# TOSHIBA

## VCR / CAMERA SERVICE BULLETIN NO:61

MODELS: M442, ~~M442C~~, ~~M442L~~,  
M447, ~~M447C~~, ~~M447L~~

SUBJECT: No Picture or Intermittent Blue Picture

Figure 4

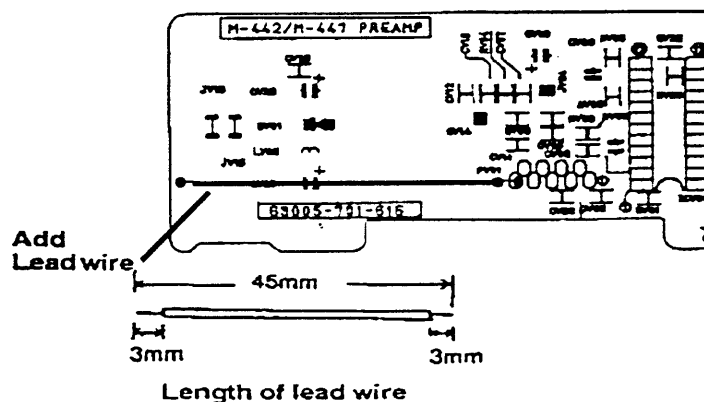
Symptom: No picture or intermittent picture due to open GND line.

1. Remove the top cover (figure 1).
2. Remove 4 screws and stand up the Main PC board unit as shown in figure 2.
3. Remove the pre-amp unit and open the shield case.  
(1 soldering point, 2 claws) (figure 3)
4. Put a lead wire as shown in figure 4 (Between GND land and pin 9 of PV01).
